**STATUS OF FEMP WASTEWATER TREATMENT UNITS AS SWMUS OR
HWMUS**

**C:OP:93-0737
DOE-FN/FERMCO OEPA
20
LETTER**

**FINAL REPORT ON THE APPLICATION OF THE MIXTURE RULE EXCLUSION TO WASTEWATERS
MANAGED IN THE FEMP WASTEWATER TREATMENT SYSTEM**

ENCLOSURE 2
RESPONSE TO SPECIFIC OEPA COMMENTS ON THE DRAFT REPORT ON FEMP'S WWTs

WASTEWATER FLOW DIAGRAM - APRIL 1990 TO FEBRAURY 1991

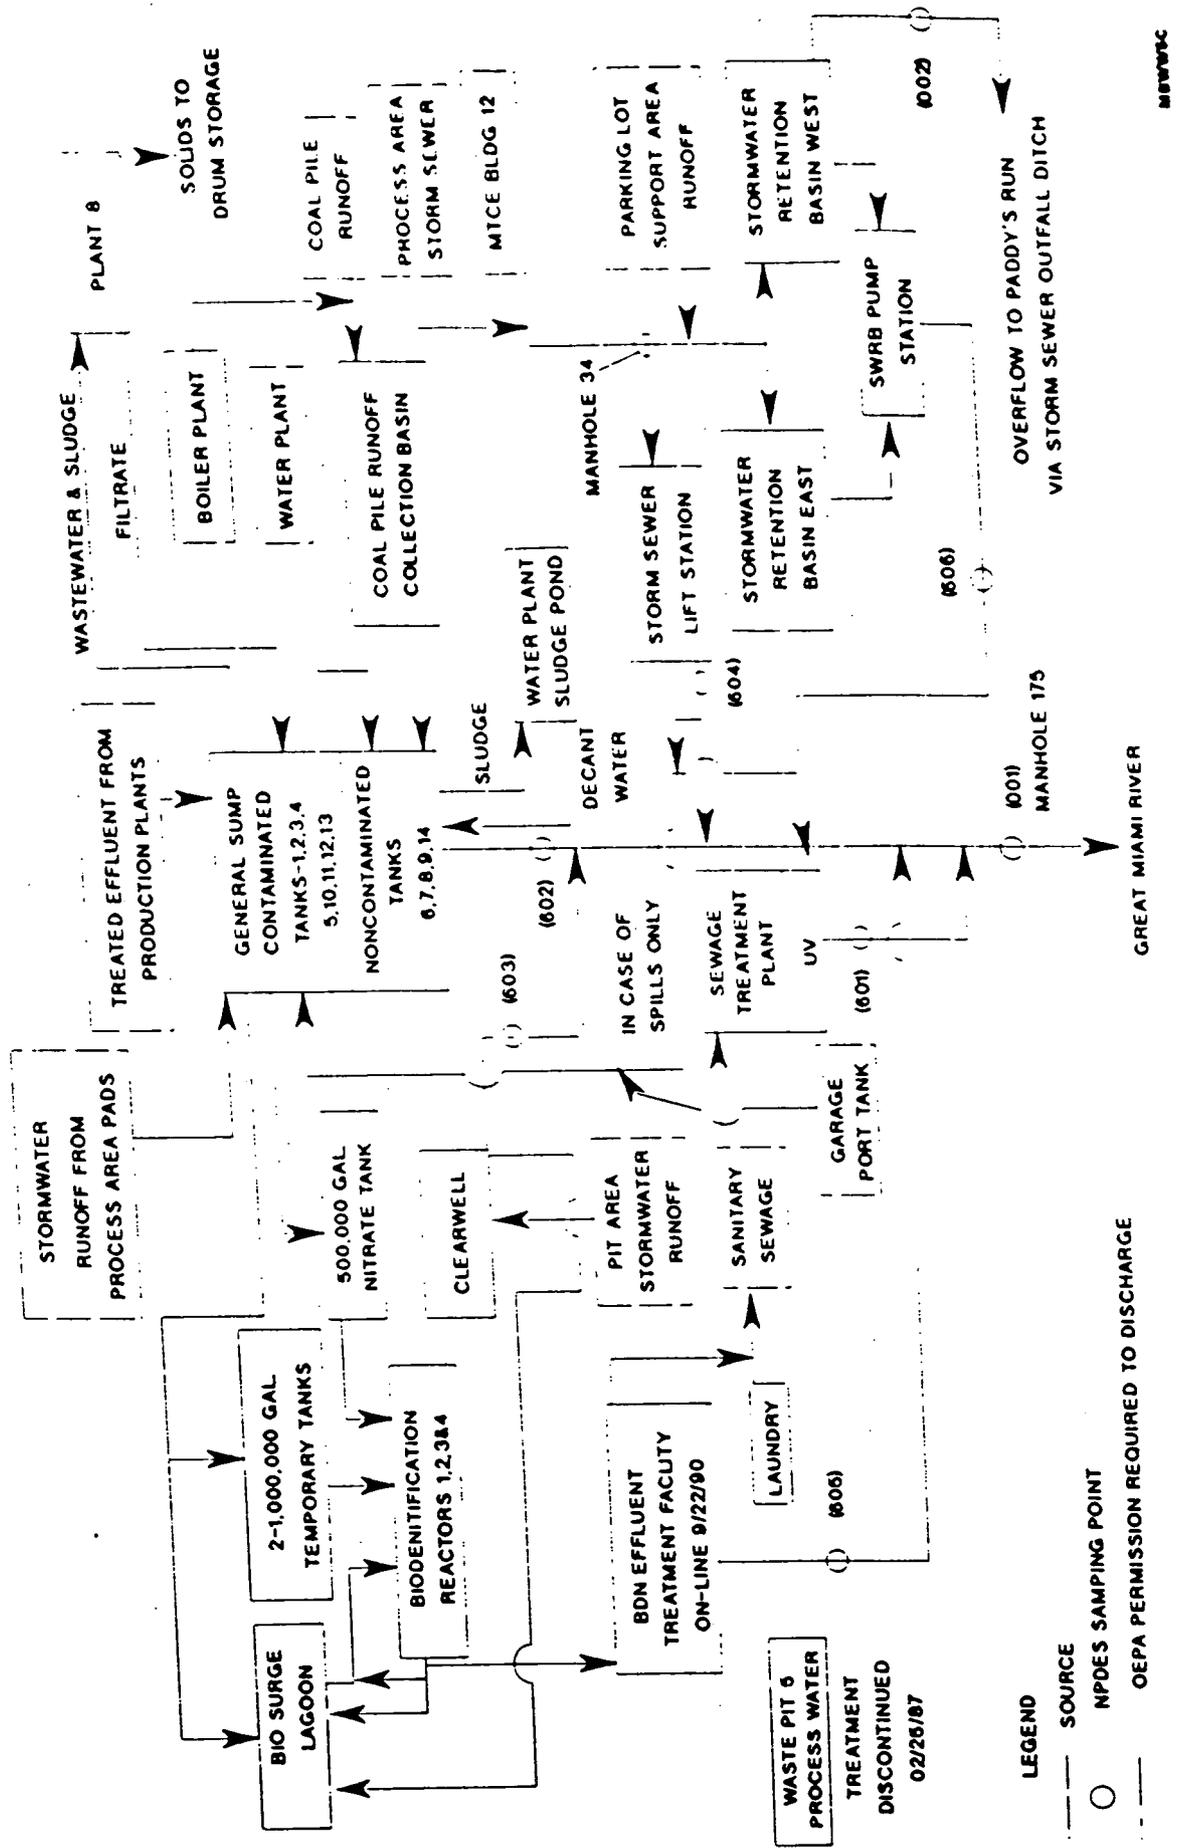
1. *Ohio EPA requests all documentation which exists to support the numbers used for wastewater flow in the 9/5/91 report for the NGS headworks calculations. Indicate any and all locations at which this flow was measured.*

The final wastewater mixture rule exclusion report uses the National Pollutant Discharge Elimination System (NPDES) Discharge Monitoring Report (DMR) data for all flows used in the calculations. The NPDES permit requires flow measurement at the final outfall 001 and the internal outfalls:

- Sanitary System - Sampling Point 601
- Noncontaminated General Sump - Sampling Point 602
- Contaminated General Sump - Sampling Point 603 (prior to 1987)
- Stormwater System - Sampling Point 604

The block flow diagrams in Attachment 1 show the location of these sampling points. A summary of the data is provided in Table 4 of the report.
